## Product Change Notification / KSRA-17VISF459

CCB 4651 Final Notice: Qualification of STA as an additional assembly site for LAN8720A device family available in 24L VQFN (4x4x0.9mm) package

### PCN # KSRA-17VISF459

Pre Change

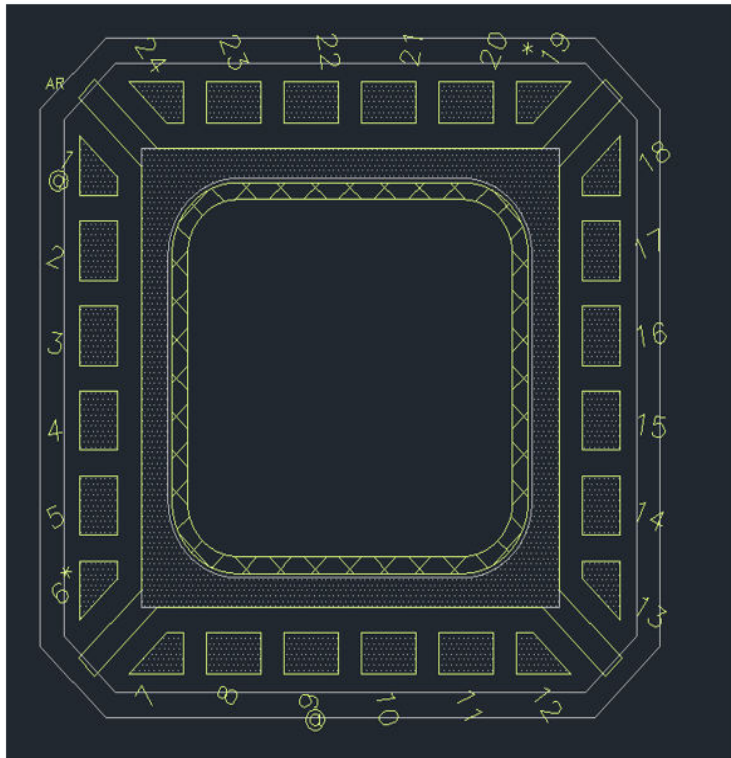
**Description of Change:** Qualification of STA as an additional assembly site for LAN8720A device family available in 24L VQFN (4x4x0.9mm) package

# Lead frame Comparison
